Huntington Beach Energy Project

(12-AFC-02C)

Data Responses, Set 1 (Response to Data Requests 1 to 74)

Submitted to
California Energy Commission

Figures A60-1b
Heat and Mass Balance - 65.8F, 58.32%RH, NO EVAP
AES Amended Huntington Beach Energy Project
Huntington Beach, California

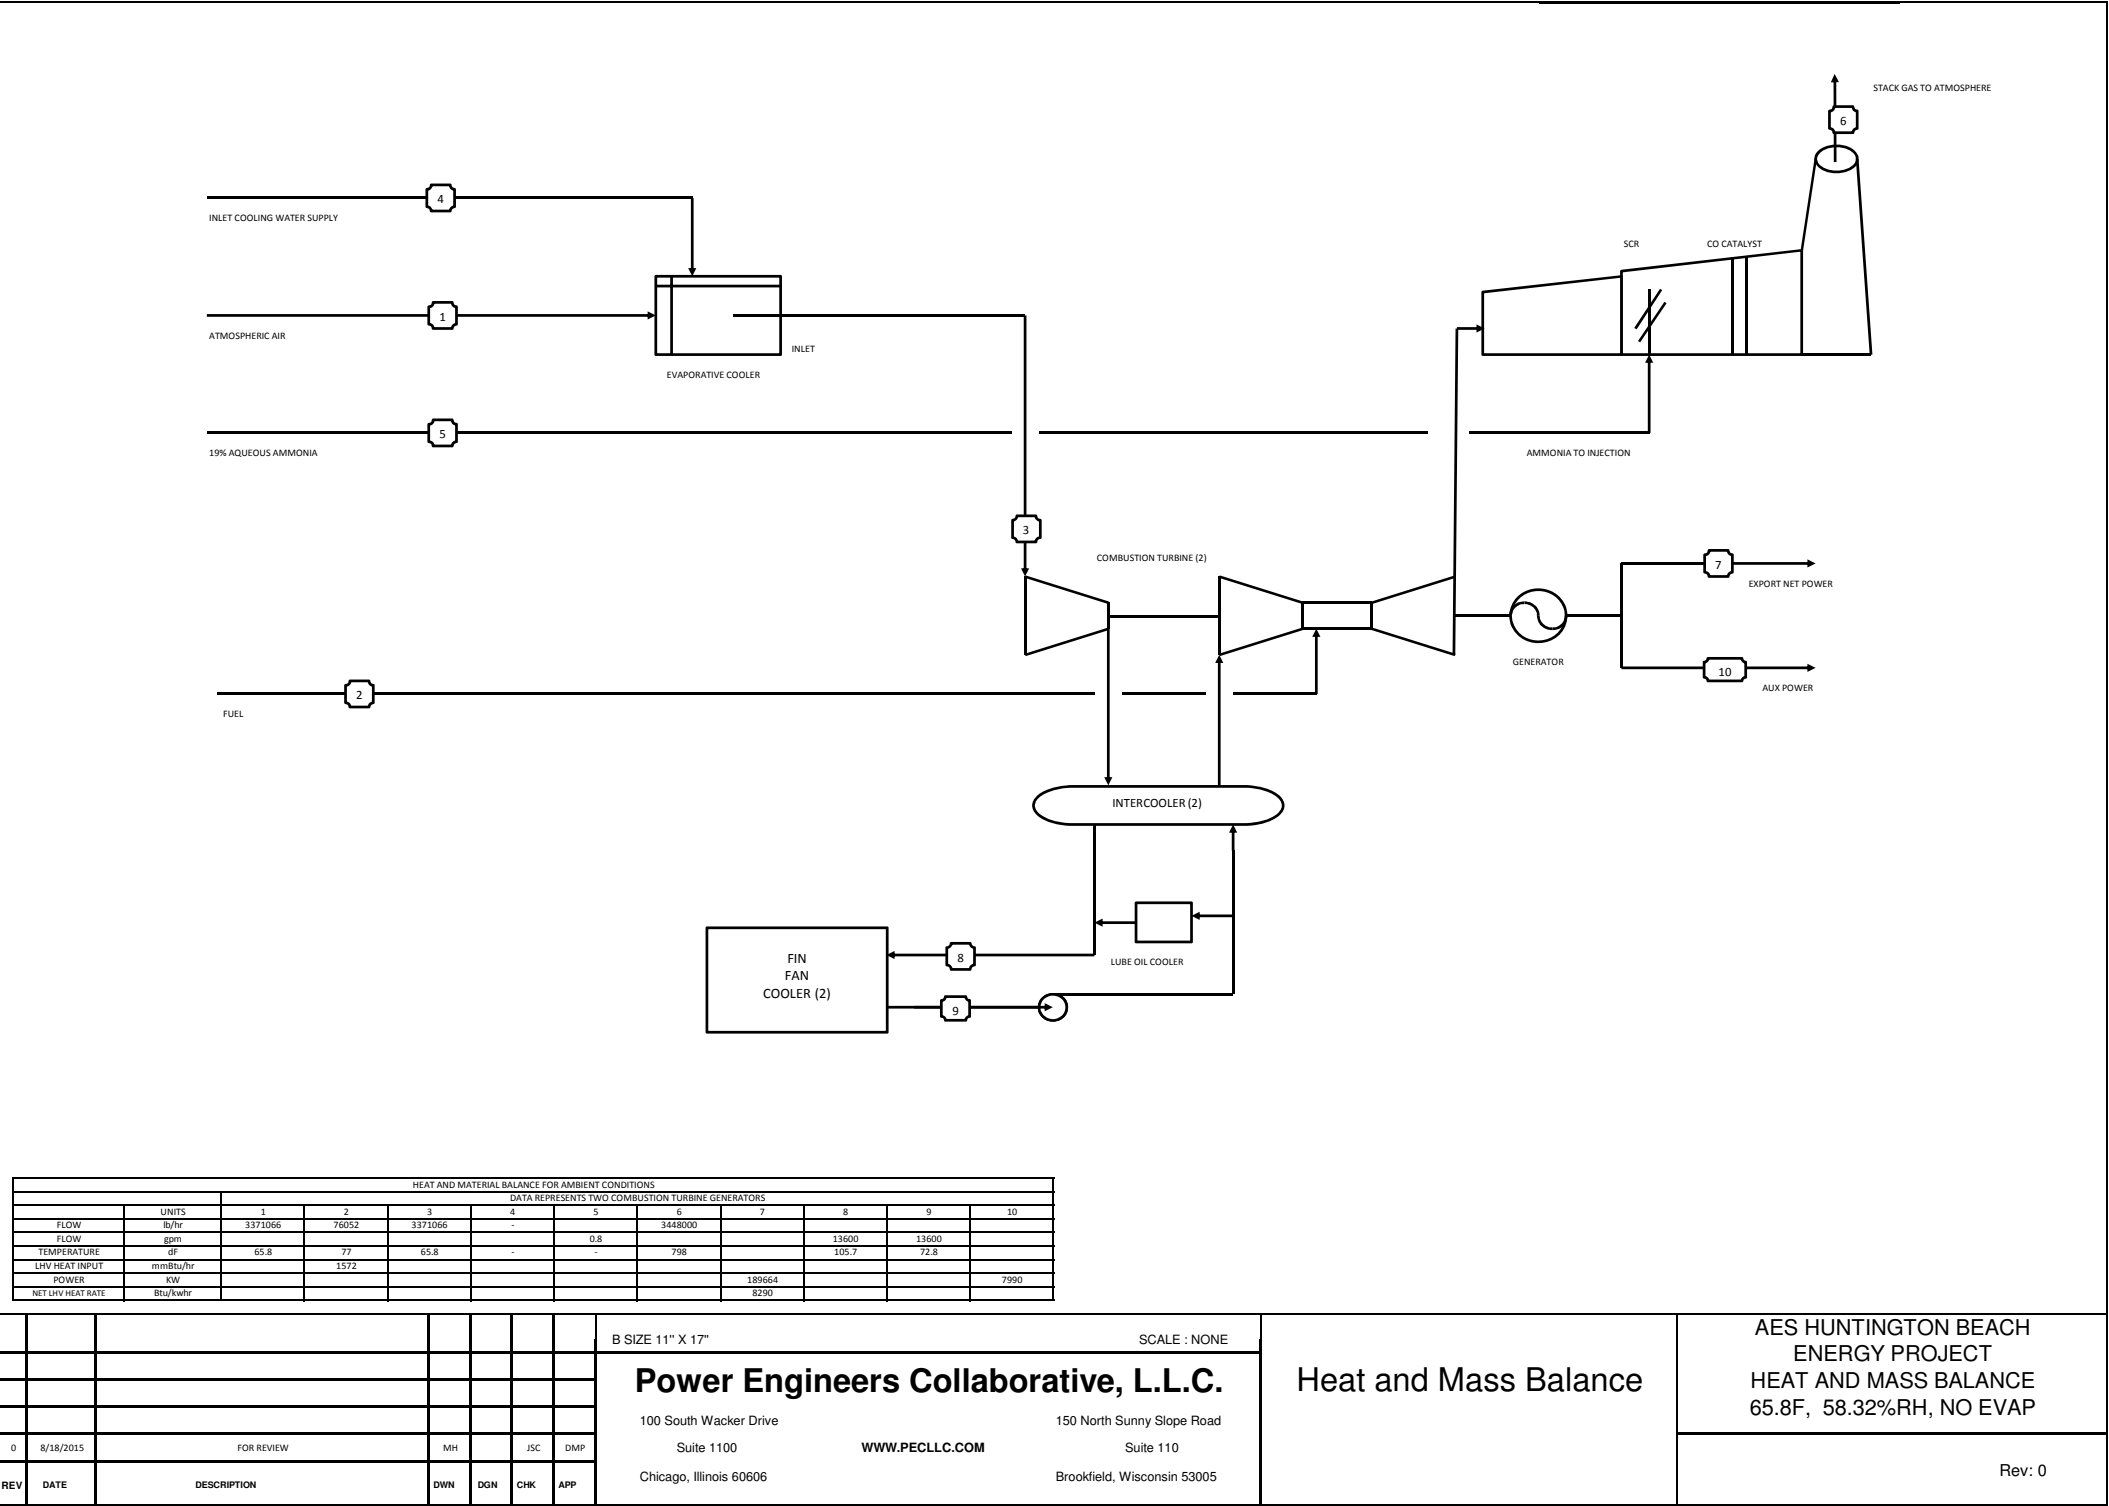
A60. Provide auxiliary load information.

Response: Amended HBEP PTA Figures 2.1-5a and 2.1-5b provide auxiliary load information for the combined cycle power block. Attached Figures 60A-1a and 60A-1b show the auxiliary load for the simple cycle power block.

Figure 2.1-2b
General Arrangement/Site Plan
AES Amended Huntington Beach Energy Project
Huntington Beach, California

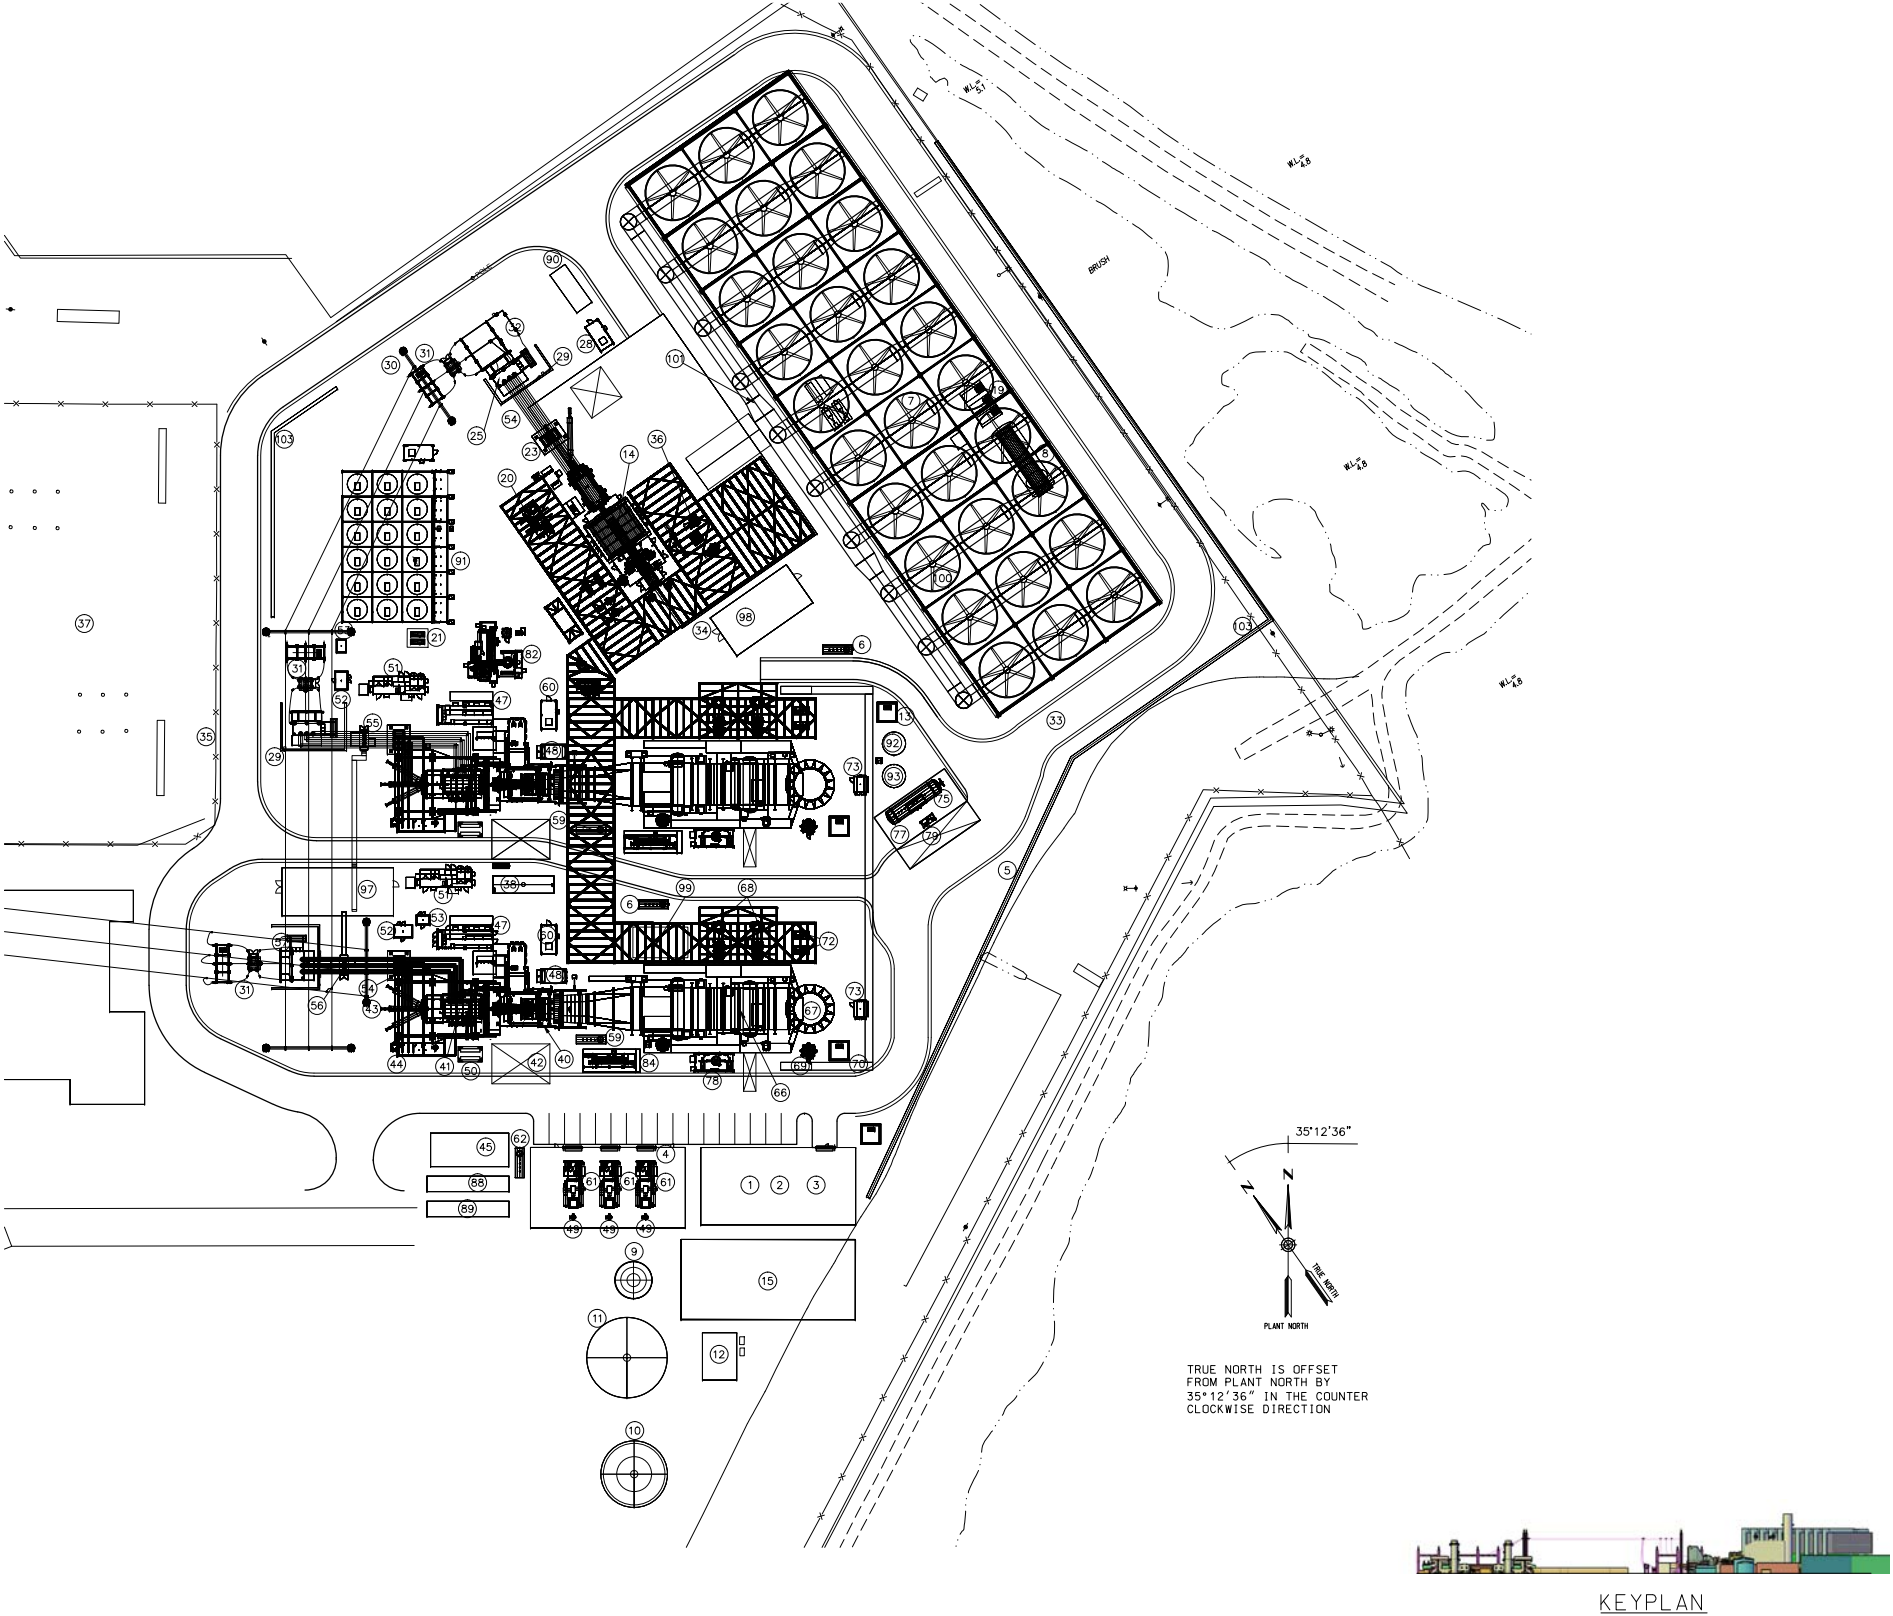
Figure 2.1-2 of the petition to amend (PTA) the Huntington Beach Energy Project (hereafter amended HBEP; see AES 2015) lacks a legend, leaving the reader to wonder what the individual components in the figure represent.

A30. Please revise Figure 2.1-2 to include a legend that identifies the project features.

The June 2012 AFC for the proposed HBEP includes **Figure 2.1-1**, “General Arrangement/Site Plan,” which labels and lists project equipment. The Petition to Amend contains a similar site plan but without a list of project equipment (**Figure 2.1-2**).

A74. Please add the equipment list and corresponding numbers to **Figure 2.1-2**, including the sound wall and the “transformer wall” listed in **Tables 5.13-1** and **5.13-2**. Please add the HBGS Units 1 and 2 concrete structures to **Figure 2.1-2**.

Response: Figure 2.1-2b and Figure 2.1-2c has been included. The figures include a legend that identifies the project features.
